## Proposal for to the 02 series of amendments of Regulation No. 137 – frontal collision with focus on the restraint system

### Submitted by the experts from Japan on behalf of Task Force

The text reproduced below has been prepared by the expert from Japan on behalf of Task Force to amend the requirements concerning post-crash electrical safety in the event of frontal collision. The modifications to the current text of the Regulation are marked in bold for new or strikethrough for deleted characters.

**Figure 3**  
**Jointed Test Finger**

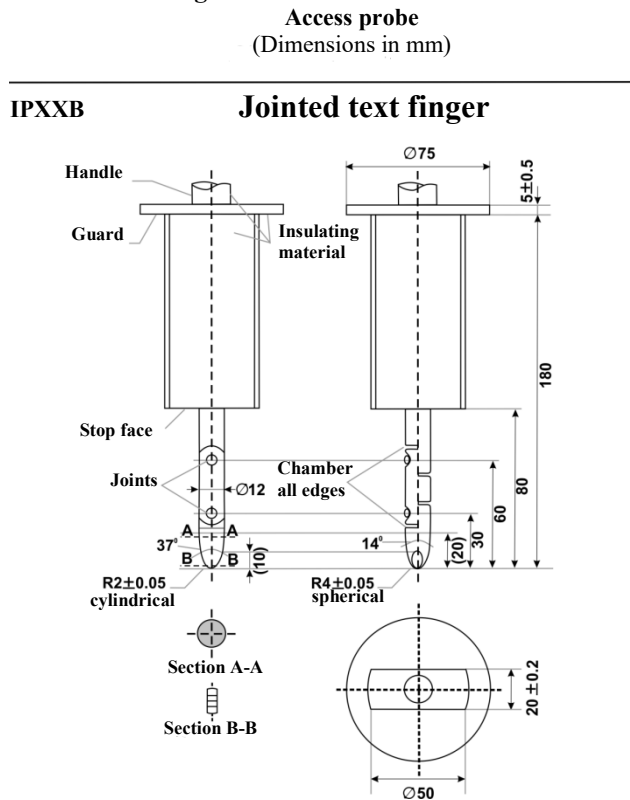
The jointed test finger described in ~~Figure 31 of Appendix 1~~ shall be inserted into any gaps or openings of the physical protection with a test force of 10 N ± 10 per cent for electrical safety assessment. If partial or full penetration into the physical protection by the jointed test finger occurs, the jointed test finger shall be placed in every position as specified below.

The requirements of paragraph 5.2.8.1.3. of this Regulation ~~are shall be considered to be~~ met if the jointed test finger described in Figure 31 of ~~Appendix 1~~, is unable to contact high voltage live parts.

Figure 4

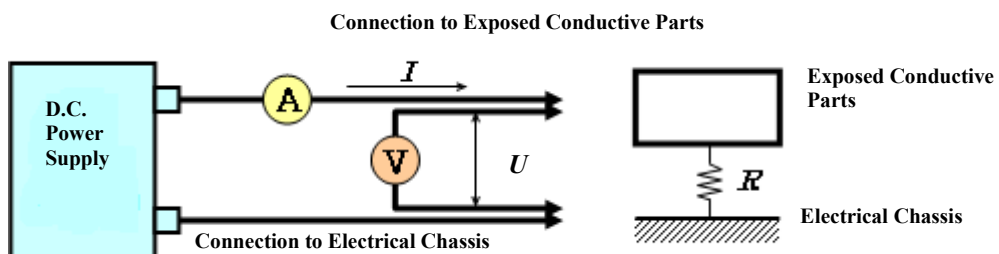
(b) Test method using DC power supply, voltmeter and ammeter.

The DC power supply, voltmeter and ammeter are connected to the measuring points (Typically, electrical chassis and electro conductive enclosure/electrical protection barrier).

The voltage of the DC power supply is adjusted so that the current flow becomes at least 0.2 A.

The current "I" and the voltage "U" are measured.

The resistance "R" is calculated according to the following formula:

The resistance R shall be less than 0.1 Ω.

*Note:* If lead wires are used for voltage and current measurement, each lead wire shall be independently connected to the electrical protection barrier/enclosure/electrical chassis. Terminal can be common for voltage measurement and current measurement.

Figure 5  
Measurement of  $U_1'$

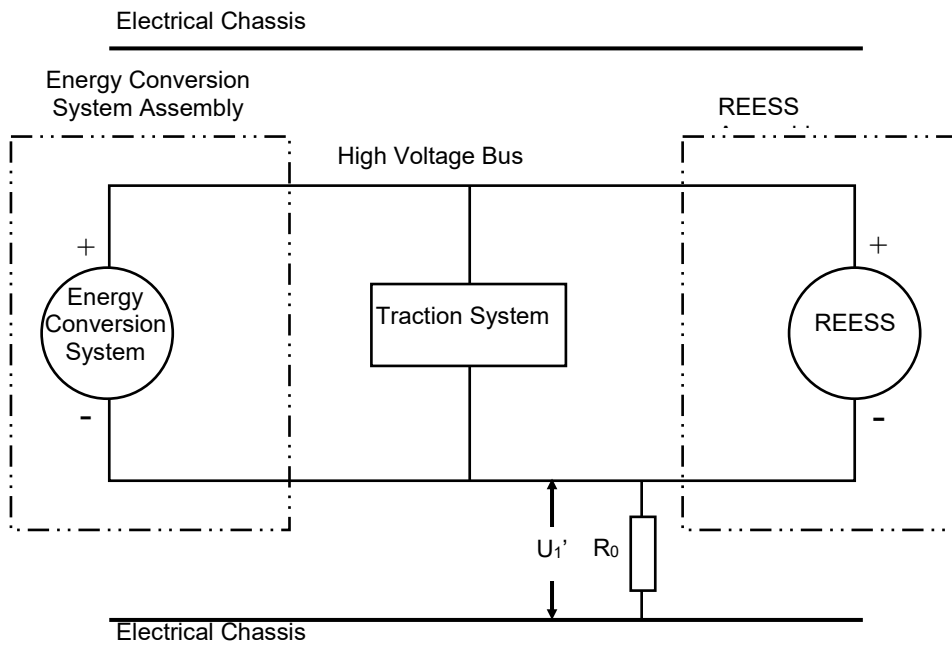
If  $U_1$  is greater than or equal to  $U_2$ , a standard known resistance ( $R_o$ ) is inserted between the negative side of the high voltage bus and the electrical chassis. With  $R_o$  installed, the voltage ( $U_1'$ ) between the negative side of the high voltage bus and the electrical chassis is measured (see Figure 5).

$$R_i = R_o * U_b * (1/U_1' - 1/U_1)$$

Figure 6  
Measurement of  $U_2'$

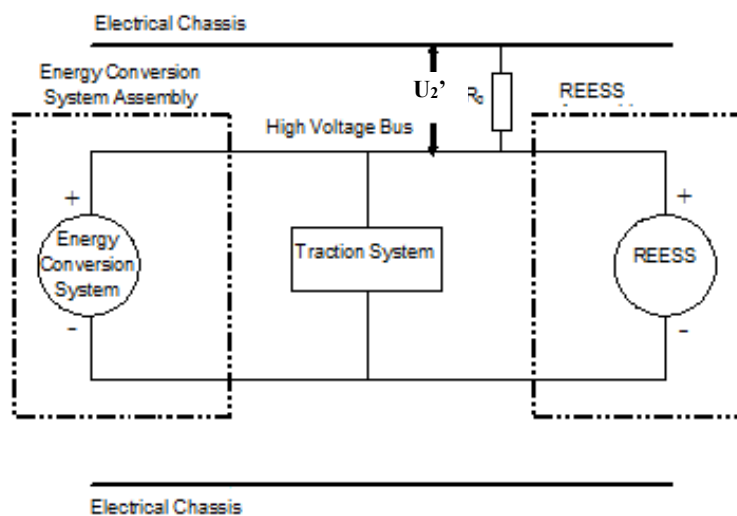
If  $U_2$  is greater than  $U_1$ , insert a standard known resistance ( $R_0$ ) between the positive side of the high voltage bus and the electrical chassis. With  $R_0$  installed, measure the voltage ( $U_2'$ ) between the positive side of the high voltage bus and the electrical chassis (see Figure 6 below). The electrical isolation ( $R_i$ ) is calculated according to the following formula:

$$R_i = R_0 * U_b * (1/U_2' - 1/U_2)$$
